FACILITY: Trojan Nuclear Plant

SUMMARY OF MEETING HELD ON OCTOBER 18 AND 19, 1979 WITH PORTLAND GENERAL ELECTRIC COMPANY AND BECHTEL TO DISCUSS THE TROJAN CONTROL BUILDING MODIFICATIONS

TROJAN CONTROL BUILDING MEETING

FIGURE 6-1

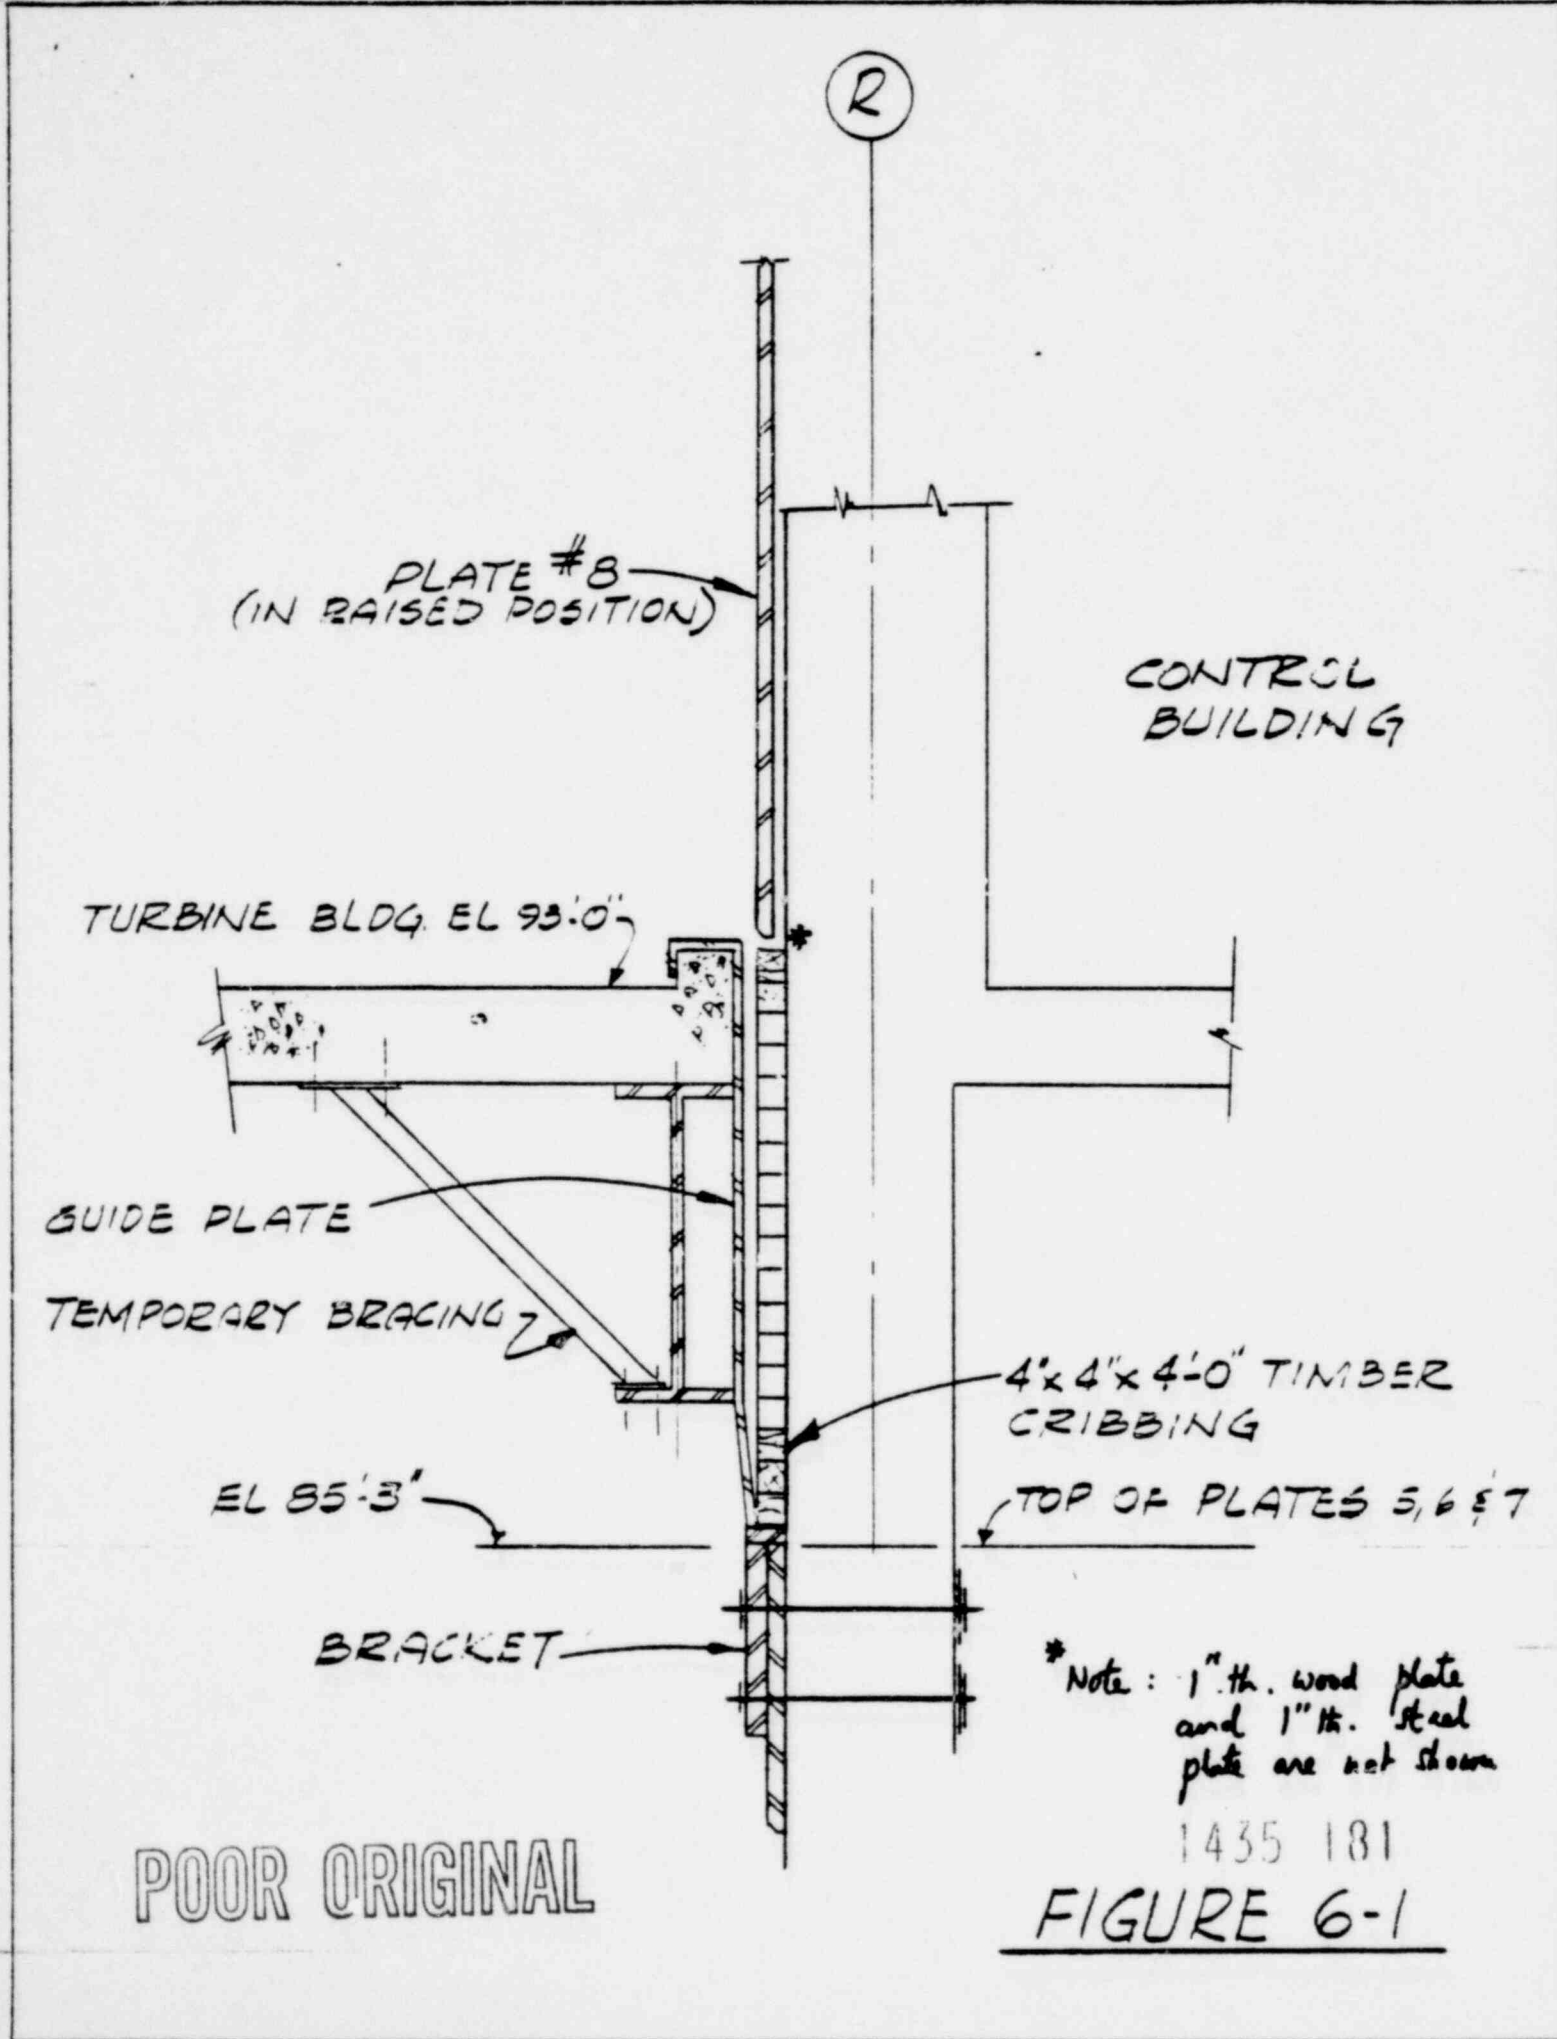
Provide the results of your analyses showing that plates 1 through 6 are sufficient to sustain without detrimental effects on plates 1-6, the structure, equipment, piping, or cable trays, the impact of plate 8 should a drop of plate 8 occur. Include (a) a detailed description of all assumptions used in the analyses, and (b) detailed justification for all of the assumptions used in the analyses, all of the loads and all of the acceptance criteria relied upon. Include an identical discussion for plate 7.

To preclude any possibility of detrimental effects on Plates 1-7, the structure, equipment, piping or cable trays should a drop of Plate 8 occur, the maximum drop height of Plate 8 will be limited to 4 inches by placing timber cribbing on top of Plates 5, 6, and 7 as shown on the attached Figures 6-1 and 6-2. The timber cribbing will consist of two piles of 4" x 4" x 4' long pieces stacked on top of each other. As the plate is being lowered, 4" thick segments will be removed one at a time from each pile, thus limiting the drop height of Plate 8 on wood to approximately 4". The last piece removed from each pile will be 1" thick, thus further reducing the drop height of Plate 8 on the plates below to 1".

The timber cribbing will be made using Douglas Fir or similar wood. It will be supported on the bottom by brackets attached to the lower plates. The cribbing will be braced laterally by guide plates designed to prevent bulging and subsequent
